**PARKS & RECREATION BOARD RECOMMENDATION 20160524-003**

Subject: The Grove at Shoal Creek PUD Application

**ENVIRONMENTAL COMMISSION MOTION FORM 20160615 008a**

Agenda Item: The Grove at Shoal Creek Planned Unit Development

□ Acreage Credits – Signature Park (13.88 acres)

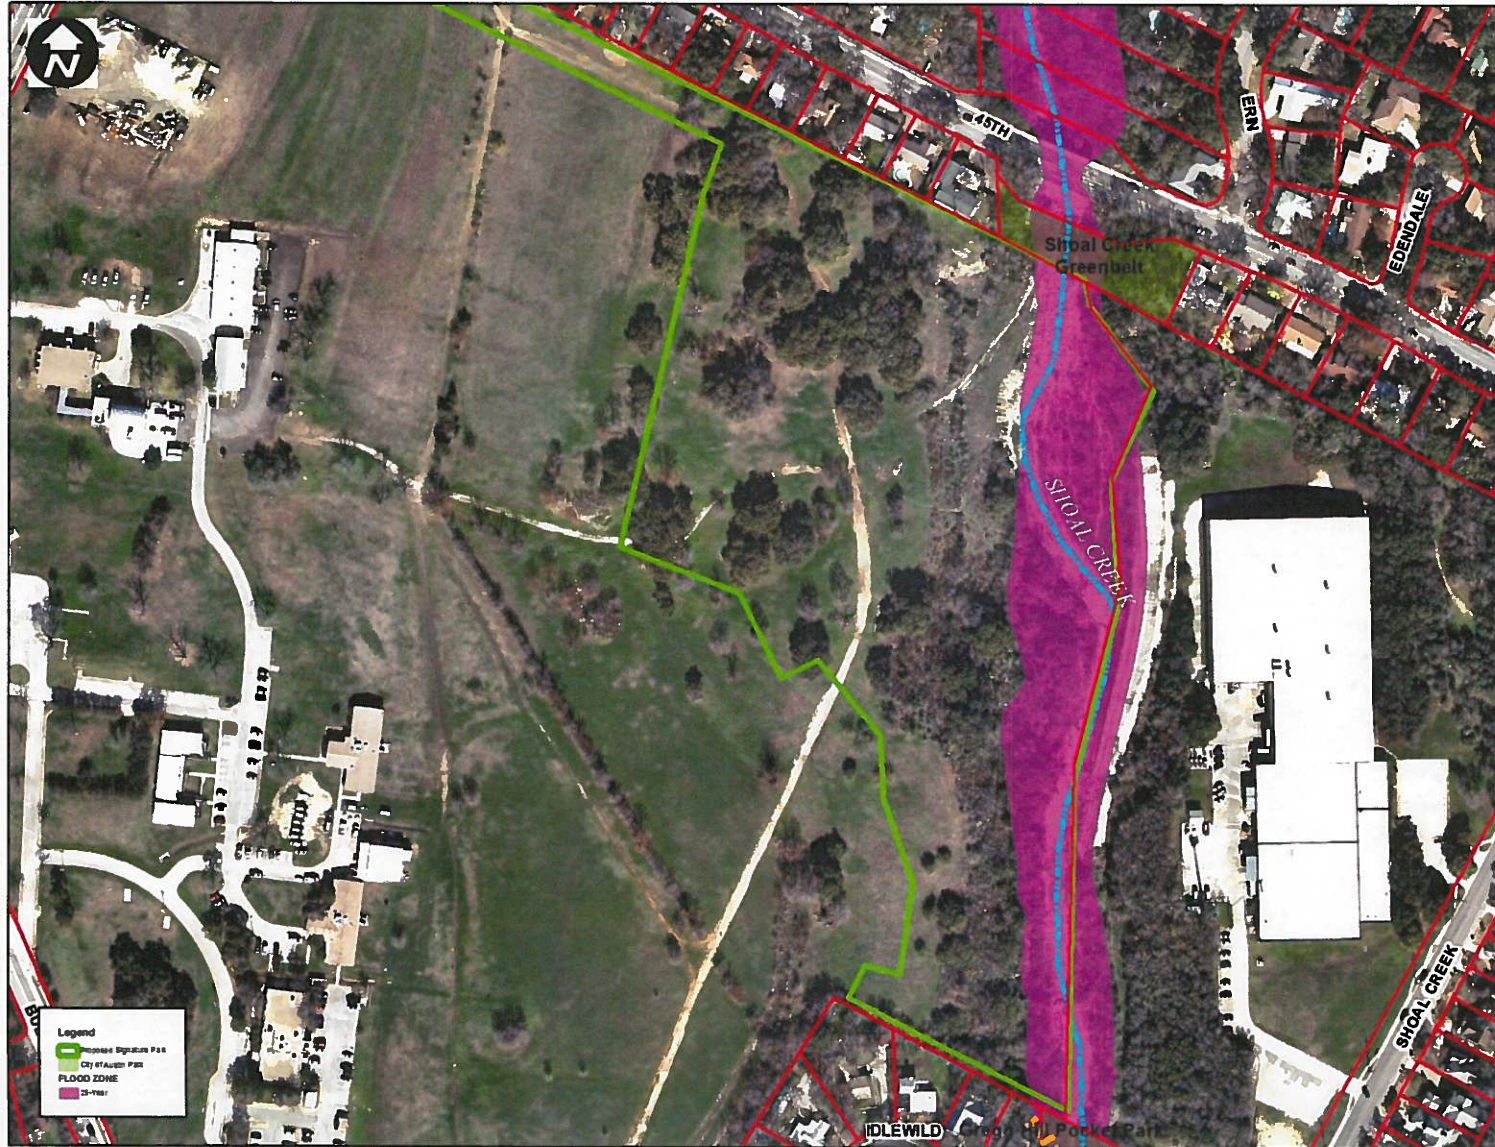
No Credit
for 25- Year
Floodplain
=
10.68 Acres

□ Acreage Credits – Signature Park (13.88 acres)

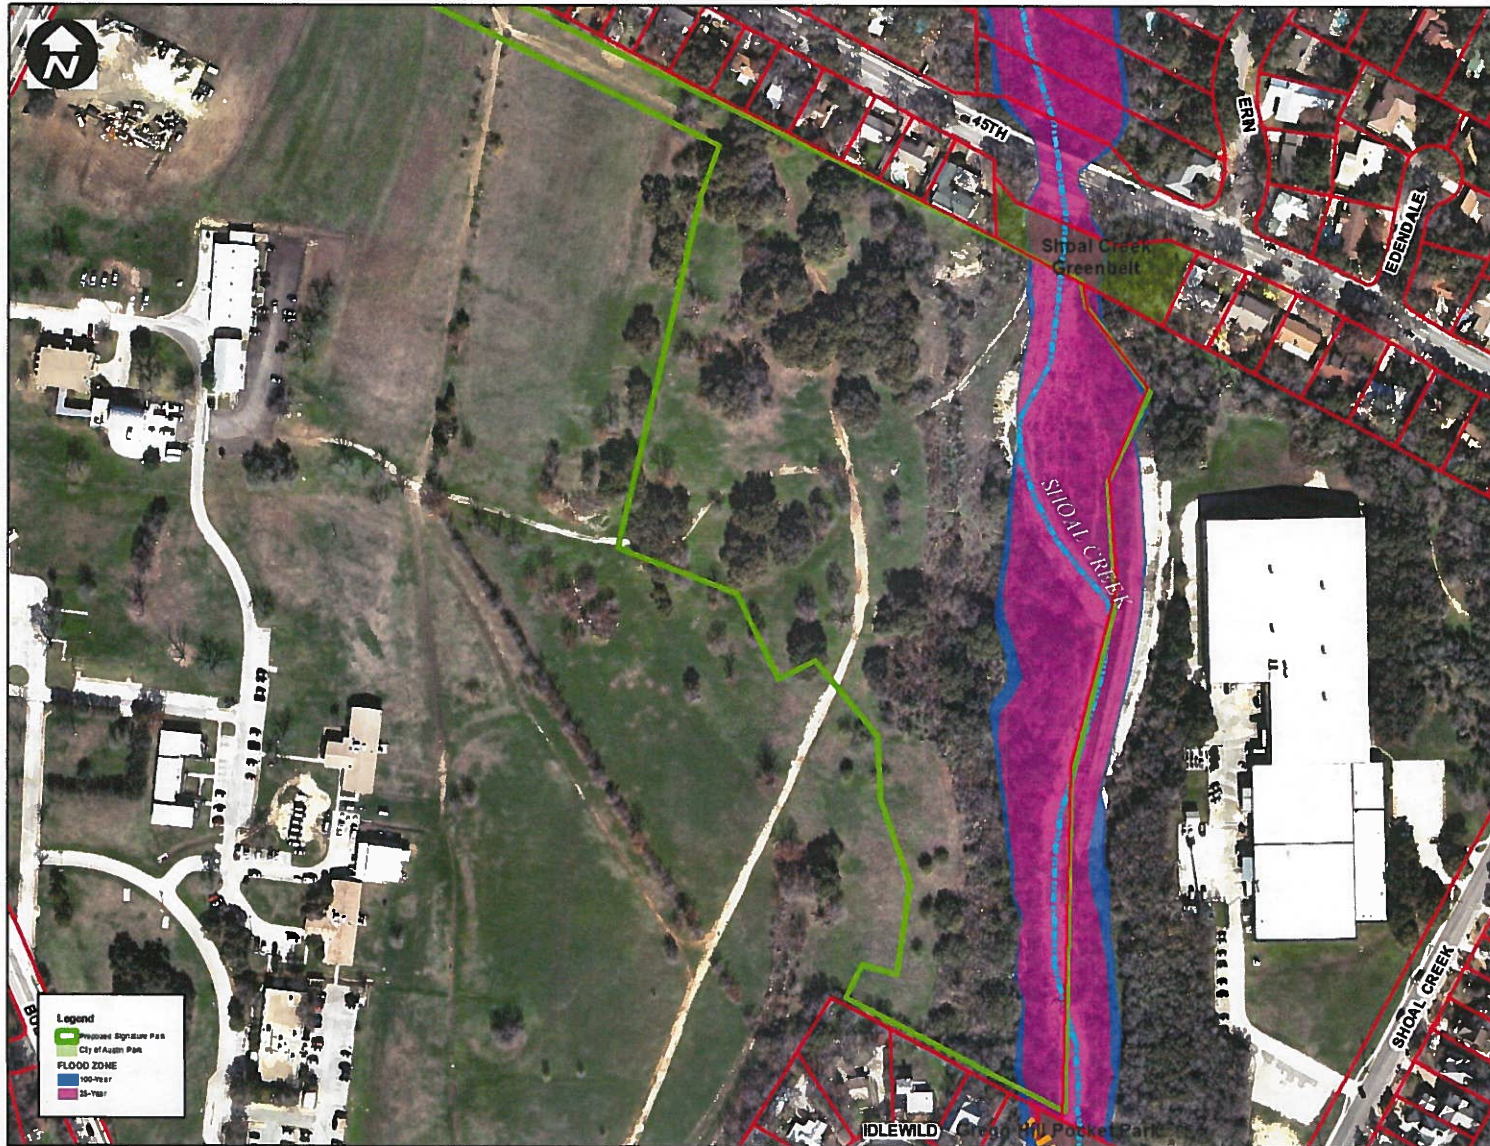
Half Credit
for 100 -
Year
Floodplain
=
10.56 Acres

□ Acreage Credits – Signature Park (13.88 acres)

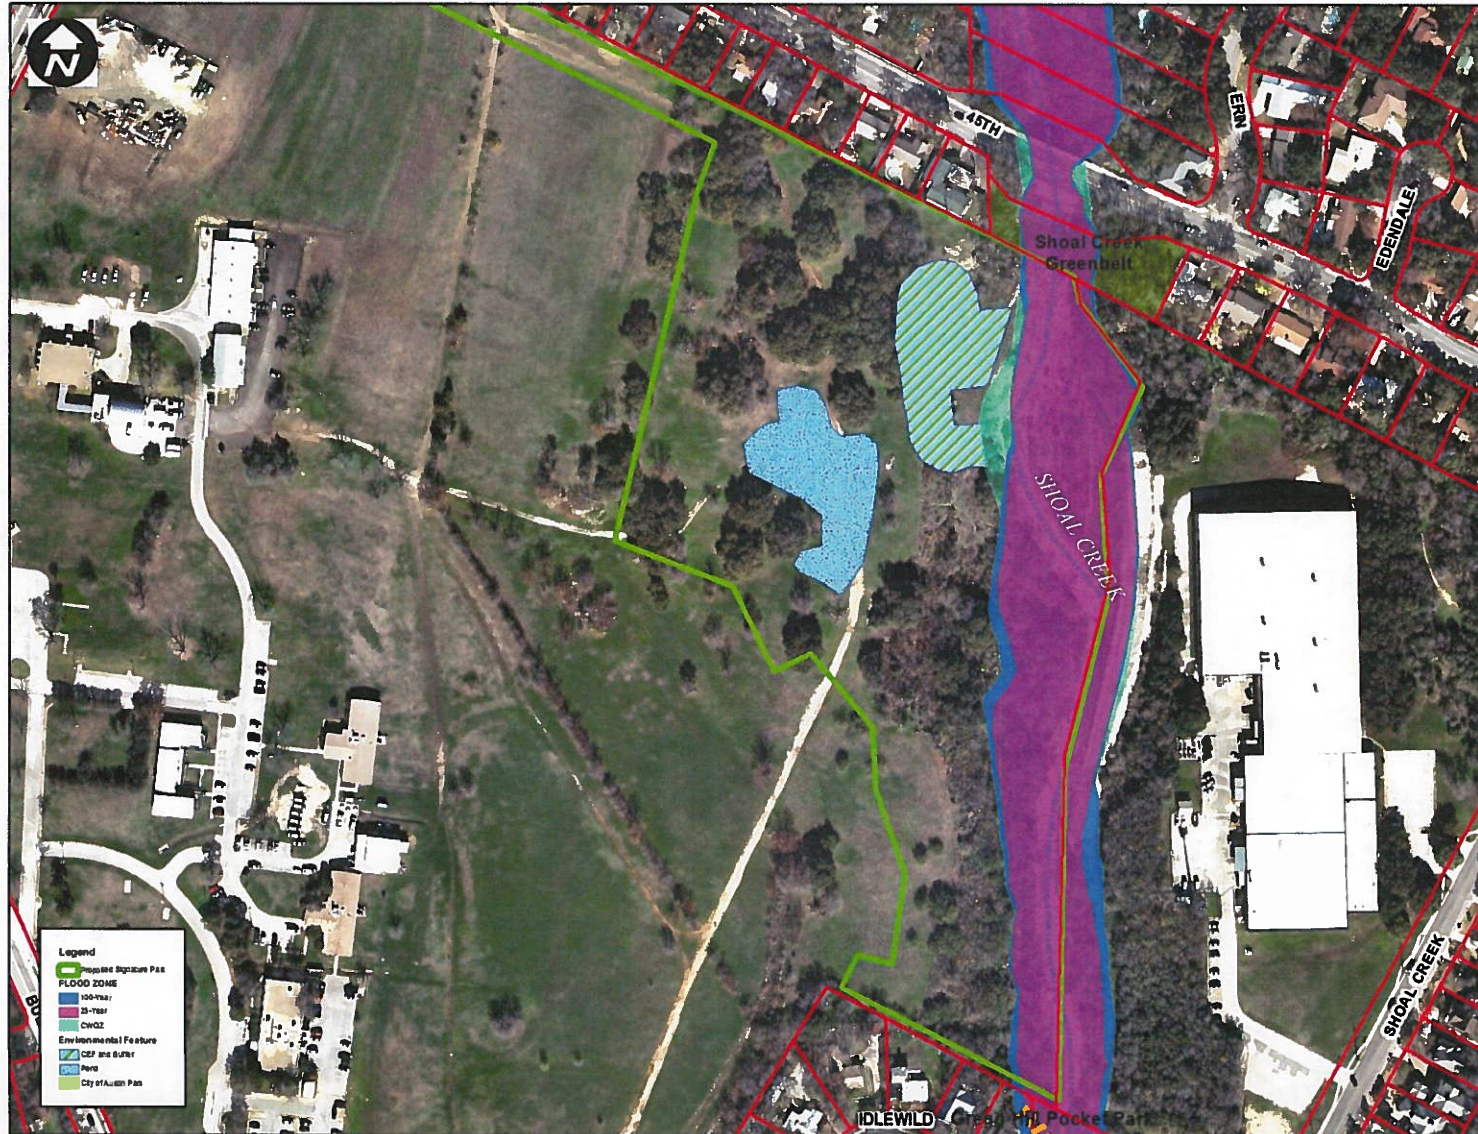
No credit for
CEF, CWQZ
and ½ of
Pond

= 8.88 Acres

❑ Standards Analysis (Active Play Areas)

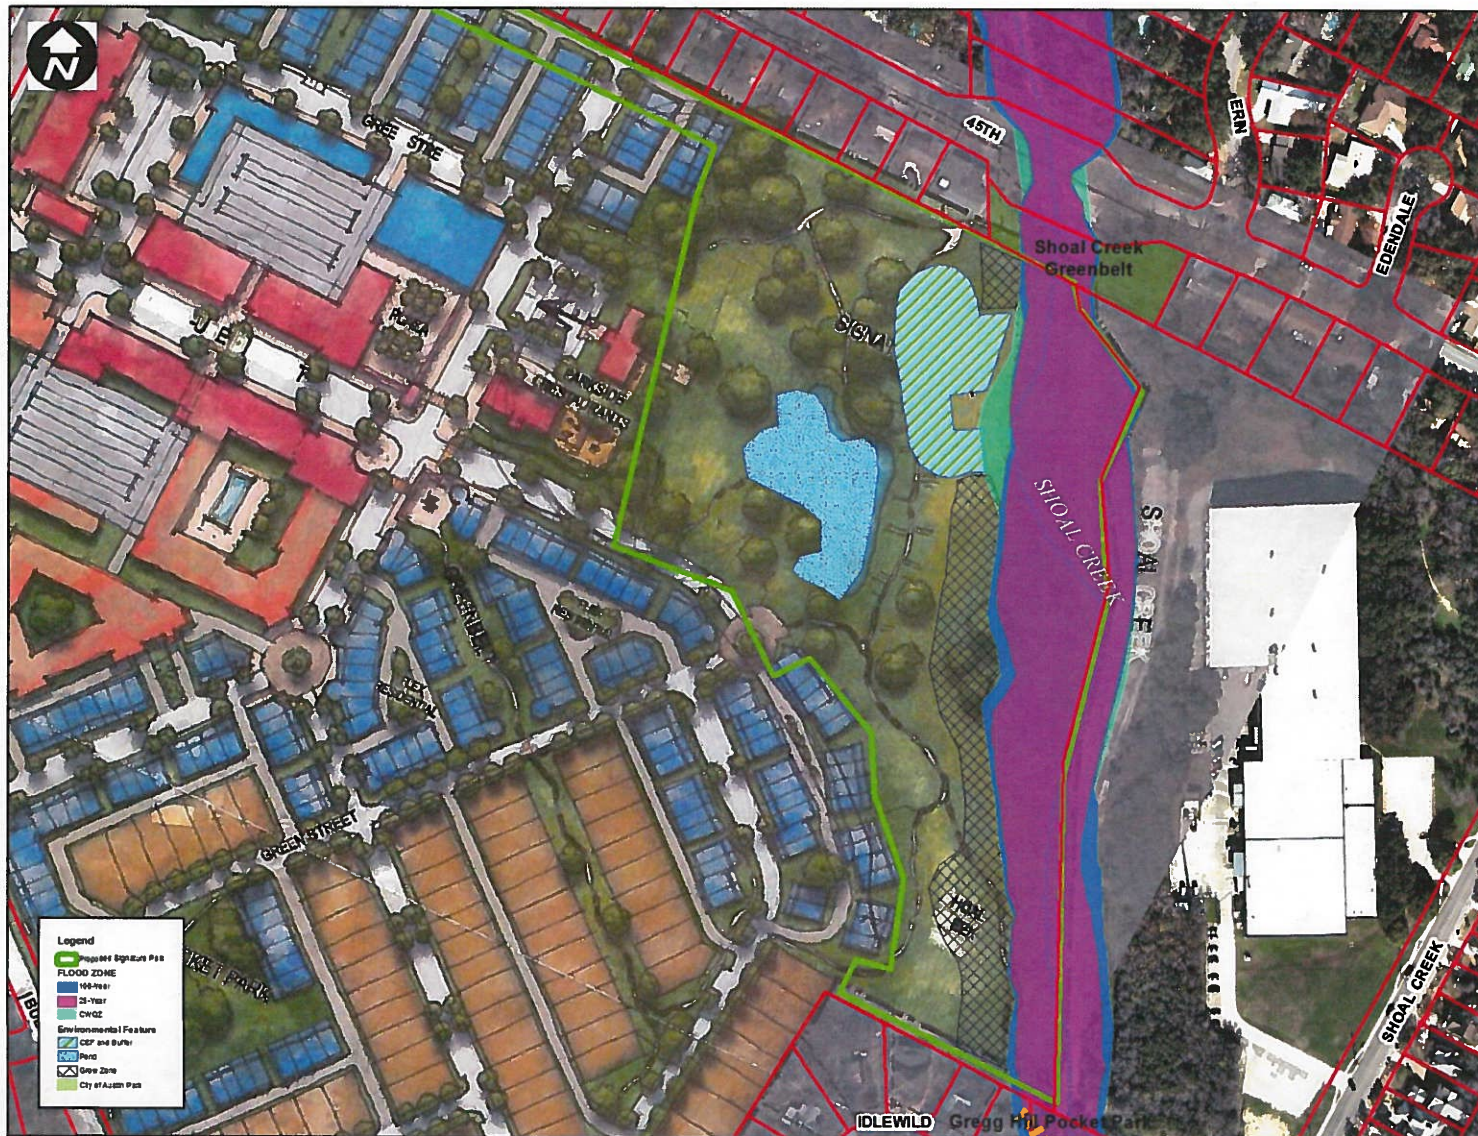
Grow Zone
= 1.6 Acres

Flowers, plants and trail crossings allowed

**=
Desired
trail uses
about 2
acres**

□ Standards Analysis (Active Play Areas)

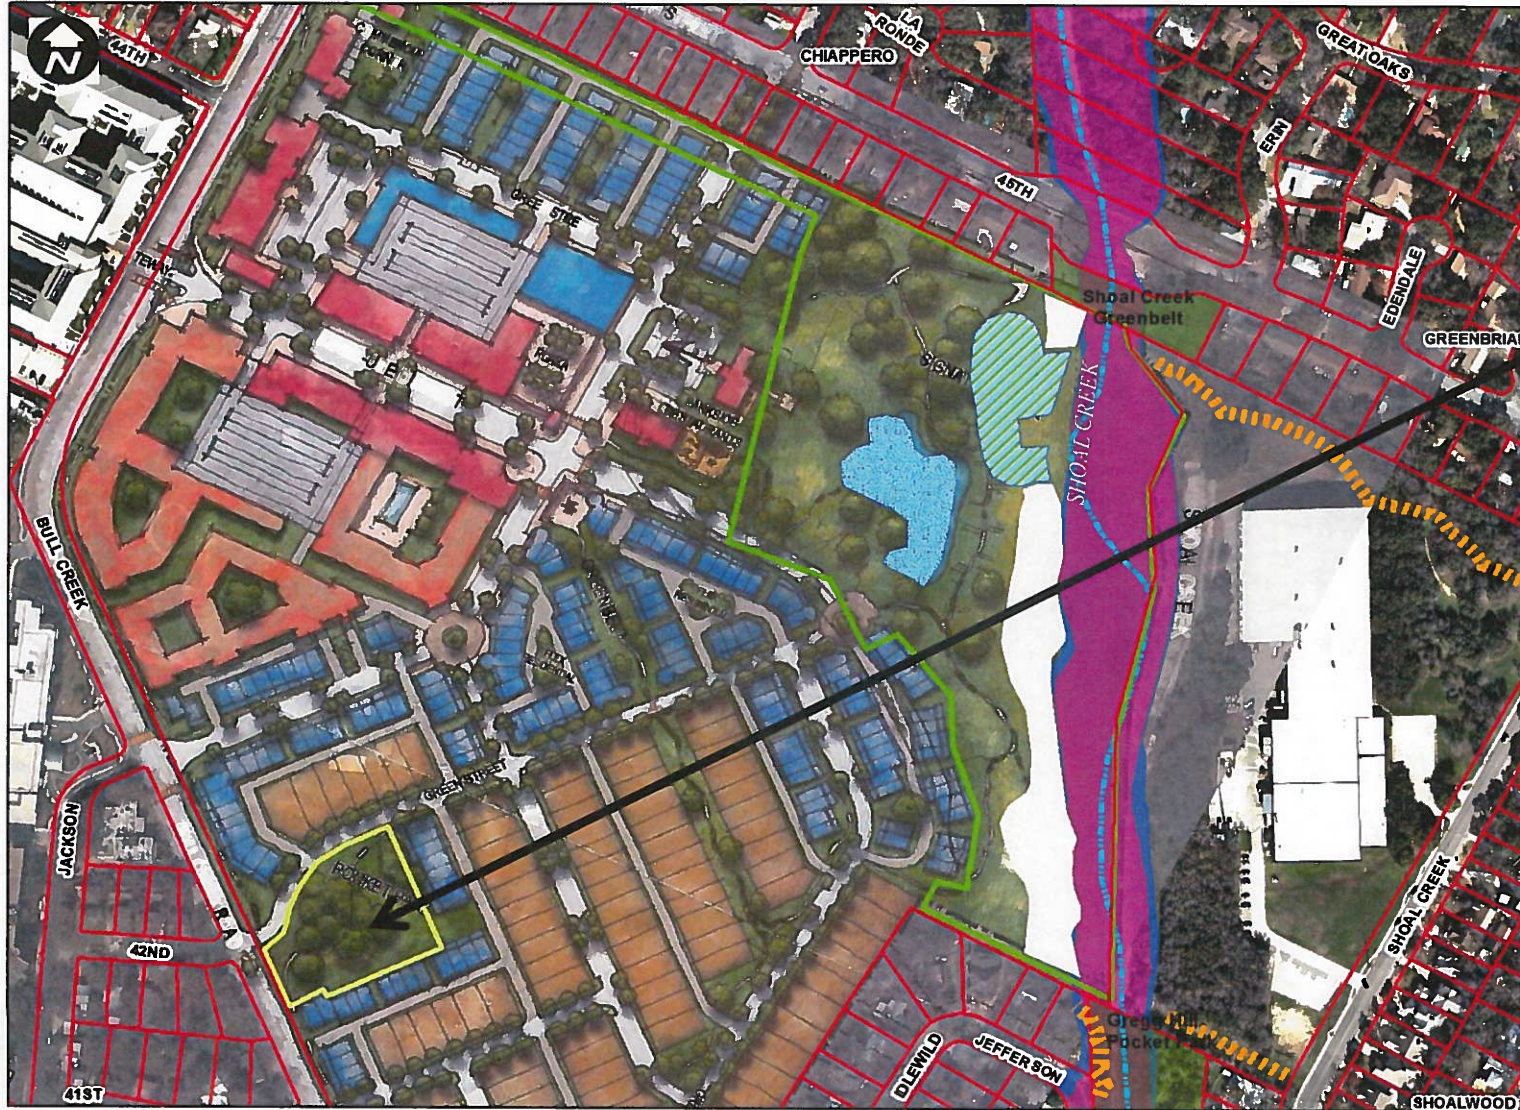
5 acres left

- Small visibility from the street
- Directly behind homes
